UNITED STATES
DEPARTMENT OF THE INTERIOR
BUREAU OF LAND MANAGEMENT

SUNDRY NOTICES AND REPORTS ON WELLS
Do not use this form for proposals to drill or to re-enter an abandoned well. Use form 3160-3 (APD) for such proposals.

| 8. Well Name and No. RJ UNIT 101 |
| 9. API Well No. 30-015-03155-00-S1 |

Lease & Well # RJ Unit #101

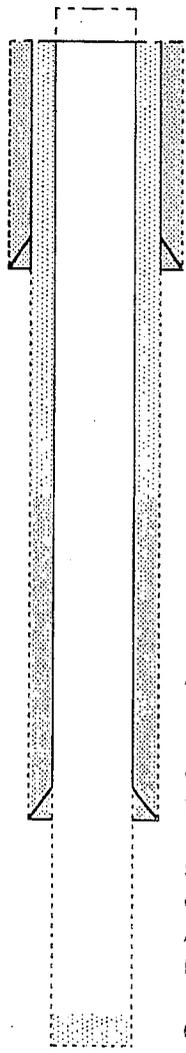
- Set 7" CIBP @ 2600'. Spot 25 sx cmt on top. Circulate hole w/ MLF. *woc Tag. (May need to Dump Bail 35' on CIBP)*
- Set 7" CIBP @ 2300'. Spot 25 sx cmt on top. Pressure test csg. to 500 psi. Circulate hole w/ MLF. *Perf @ 675. SQZ Cmt to 575. woc Tag (Base Salt)*
- Perf & Sqz 55 sx @ 395-295. WOC & Tag. 210 (Shoe & Top Salt).
- Perf & Sqz 45 sx @ 60' to surface.
- Cut off wellhead and weld on ~~Below~~ Ground Dry Hole Marker.

** BLM REVISED **

Lease & Well # RJ Unit #101

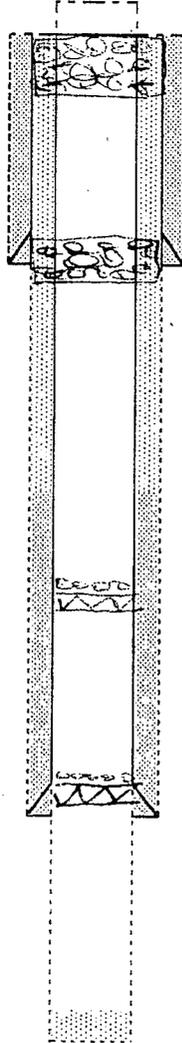
④ P-11 S₂ 45' STC
60' - surface

③ P-11 S₂ 55' STC
395' - 295' TAG

② 7" CFBPC 2326' w/
25' SK

① 7" CFBPC 2600' w/
25' SK
